The Commission has issued the enclosed Amendment Nos. 80 , 76 and 49 to Facility License Nos. DPR-33, DPR-52 and DPR-68, respectively, for the Browns Ferry Nuclear Plant, Unit Nos. 1, 2 and 3. These amendments consist of changes to the Appendix B Environmental Technical Specifications in response to your request dated July 29, 1981 (TVA BFNP TS 165).

BROWNS FERRY NUCLEAR PLANT, UNIT NO. 2

Amendment No. 76
License No. DPR-52

ATTACHMENT TO LICENSE AMENDMENT NO. 76

THE OFFICE OF POWER
 ORGANIZATION FOR OPERATION
 OF NUCLEAR PLANTS
 Figure 5.2-1
 BROWNS FERRY NUCLEAR PLANT

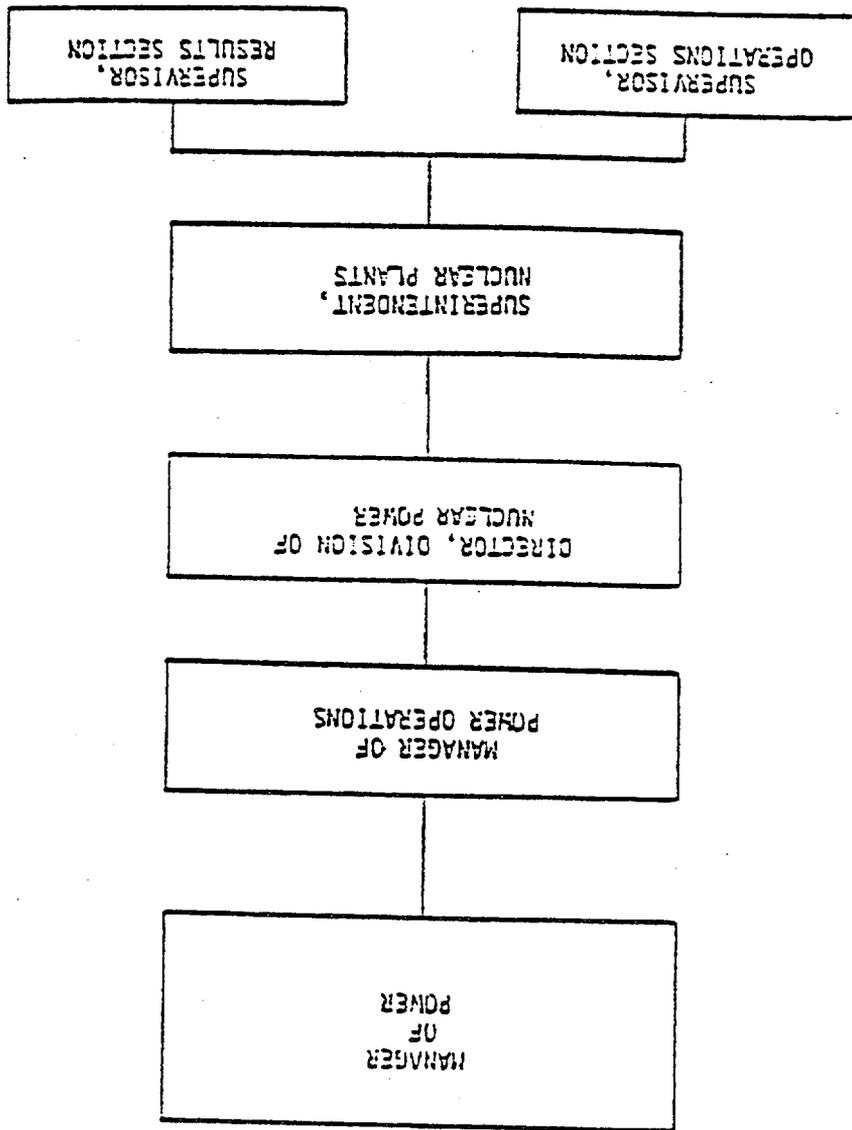
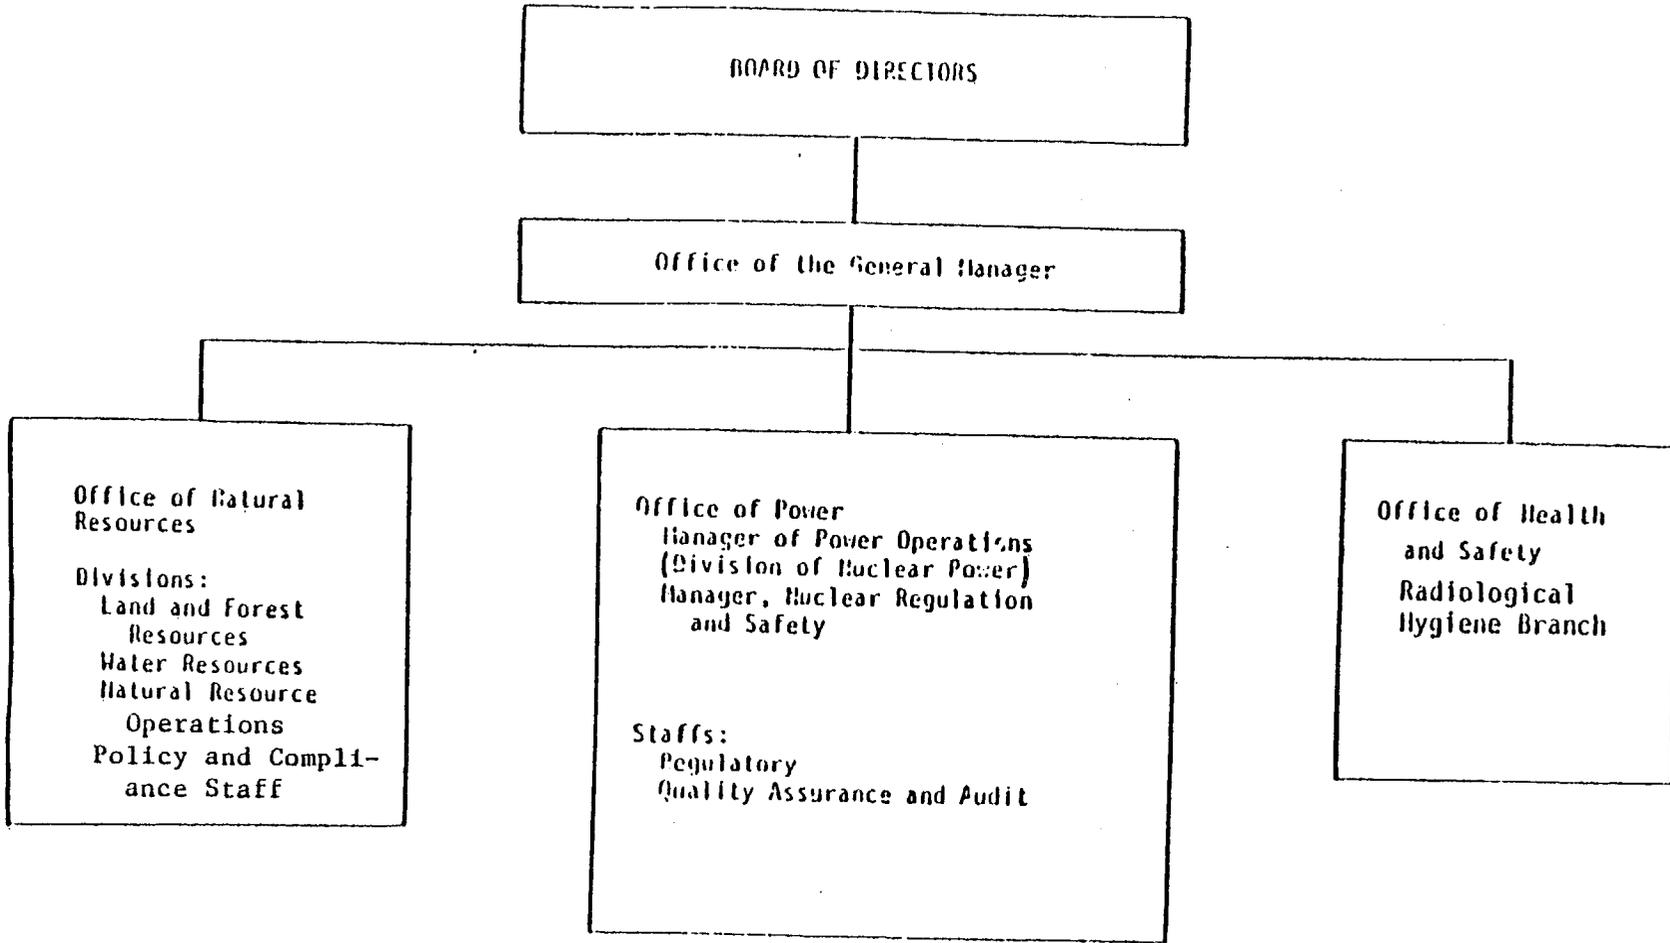
1. Delete the requirements in Section 4.1 for water quality surveys, thermal plume mapping, benthic monitoring, phytoplankton monitoring, zooplankton monitoring, fish population studies, entrainment studies on fish eggs and larvae and reference to a special study on chlorination which was completed several years ago.
2. Change the titles in Section 5.0 (Administrative Controls) of the offices within TVA responsible for environmental activities.

Operating requirements identified in Section 4.1 are duplicate to those conditions regulated by Browns Ferry Nuclear Plant's NPDES Permit No. ALO022080 which was issued to TVA on June 30, 1977. The NPDES permit specifies the specific effluent limitations for thermal, chemical, and sanitary waste discharges originating from the facilities and reporting requirements necessary to determine compliance with the effluent limitations. The existing limiting conditions of operation on water quality and the aquatic monitoring and reporting requirements are being deleted from the Browns Ferry Environmental Technical Specifications as a matter of law. Since the deletion of these conditions is a ministerial action required as a matter of law, no environmental impact assessment need be prepared as a condition precedent to taking this action. The changes to Section 5.0 - Administrative Controls to change the titles and organizational elements within TVA responsible for environmental activities is being made to reflect recent organizational changes within TVA.

- 5.2.1 The organization of TVA management which directly relates to operation of the plant is shown on Figure 5.2-1.
- 5.2.2 The principal organizations within TVA which are concerned with environmental matters related to nuclear power plant operations are the Office of Power, Office of Natural Resources, and the Office of Health and Safety. The Office of Power is directly responsible for operating the plant in accordance with specified requirements and conducting onsite monitoring. The Office of Natural Resources and the Office of Health and Safety are responsible for providing technical guidance, assistance, monitoring, and other services as needed for environmental compliance. The organizations above report to the General Manager as shown in Figure 5.2.1.
